APPLICATION NO: 20/01788/FUL	OFFICER: Miss Michelle Payne
DATE REGISTERED: 16th October 2020	DATE OF EXPIRY : 15th January 2021
WARD: Leckhampton	PARISH: LECKH
APPLICANT:	Miller Homes
LOCATION:	Land At Shurdington Road Cheltenham
PROPOSAL:	Full planning application for residential development comprising 350 dwellings, open space, cycleways, footpaths, landscaping, access roads and other associated infrastructure

REPRESENTATIONS

Reference 2 Environment Agency Map and Close up 94 Shurdington Road

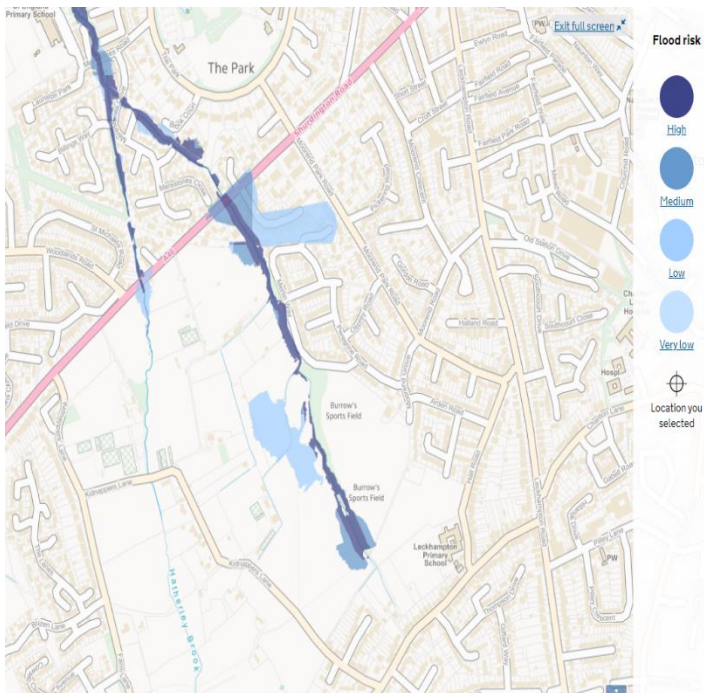
Our house is awfully close to the Zone 3 at the culvert. All of the following developments develop nearly all of the land East of the A46, land which has low permeability.

2. All of the schemes are best guesswork and do not take into account Global Warming.

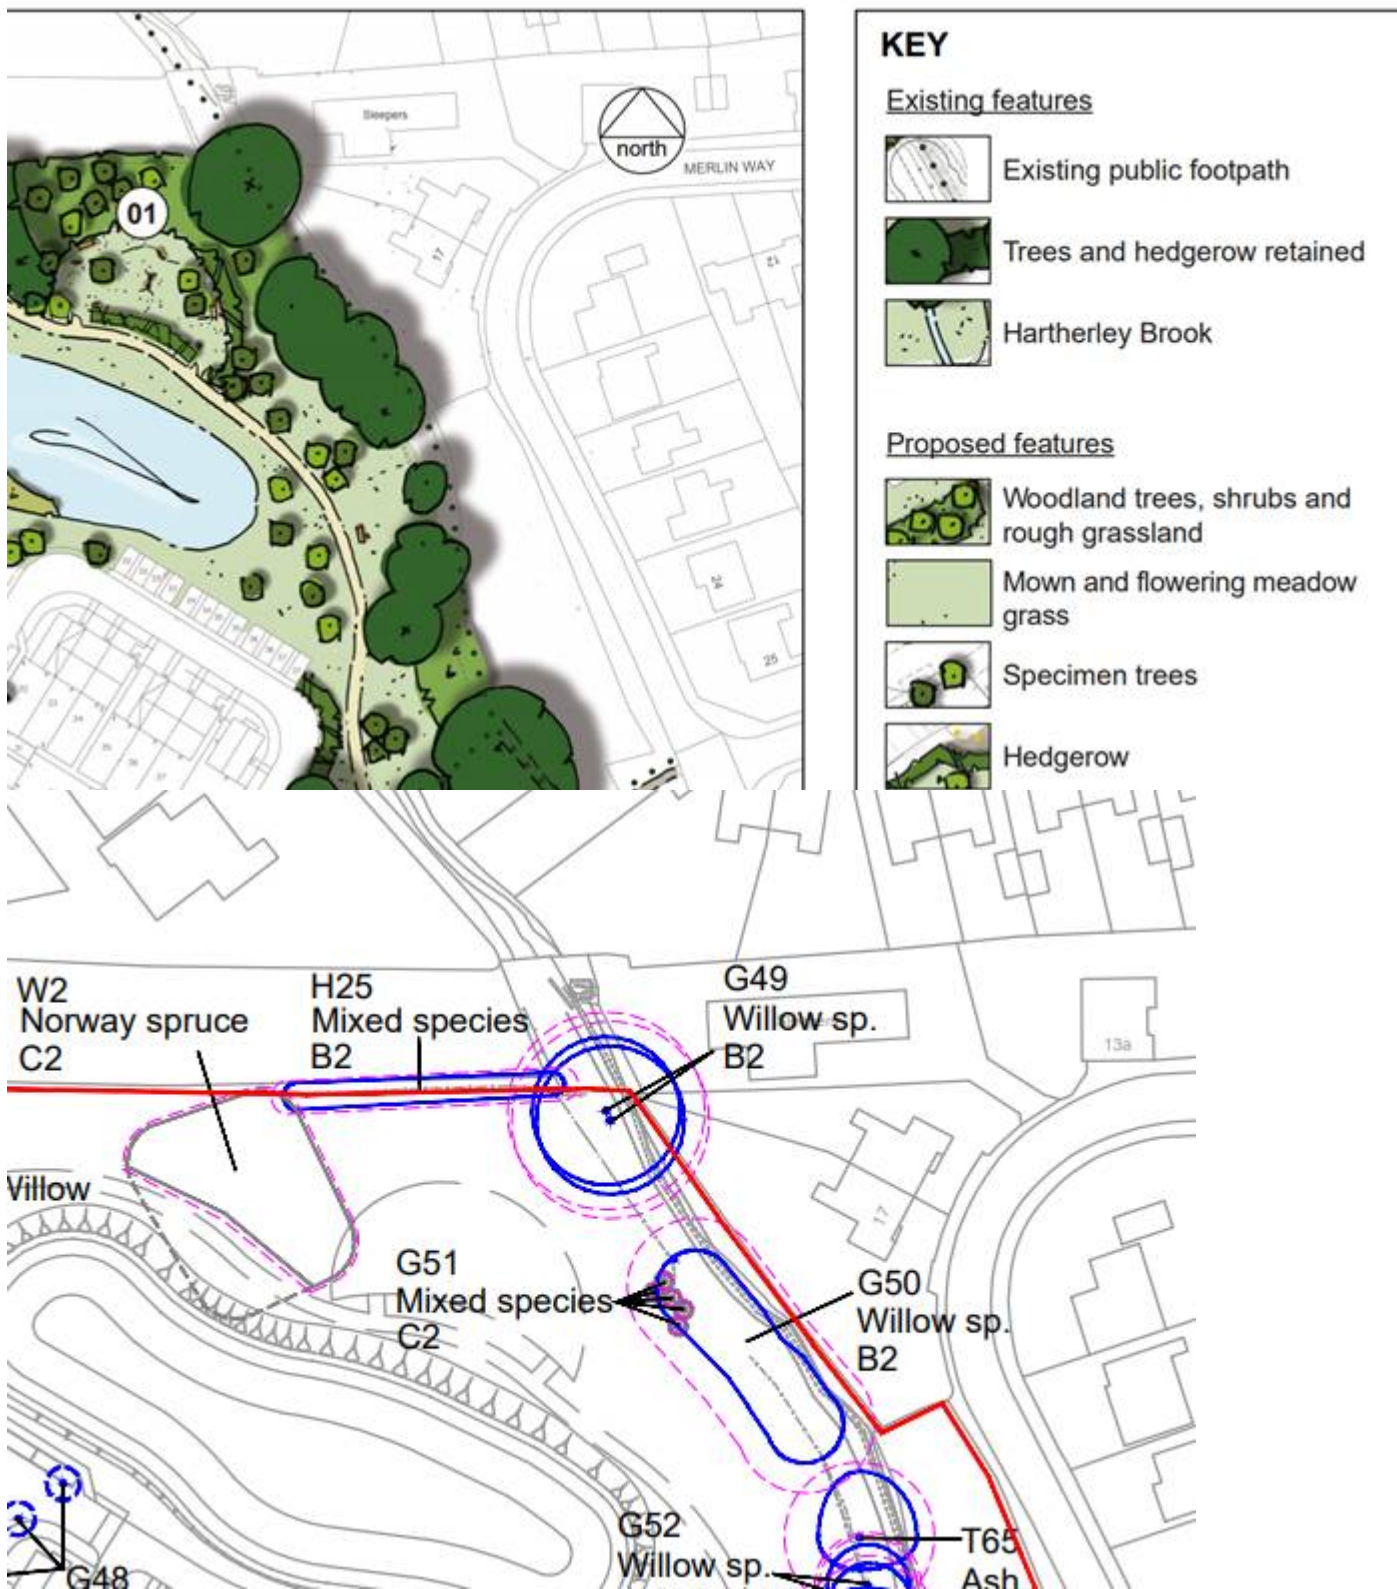
I am particularly concerned that the existing tree line could be effected along the northeast boundary. The Phase 1 Drainage Layout actually states that a tree will be removed to facilitate the proposed drainage outfall from Pond B (see extract below).

Not only do I find this unacceptable as it will significantly increase the visual impact of the proposed development from my property, it also directly conflicts with the developer's own Landscape Strategy (see extract below) and Tree Retention Plan (G49 on the extract below) that explicitly state the tree is to be retained. I would request that explicit assurances are sought from the Developer to ensure the trees along the brook are retained, as noted on their own plans, and that an alternate solution is provided for the drainage outfall that doesn't affect the existing trees.
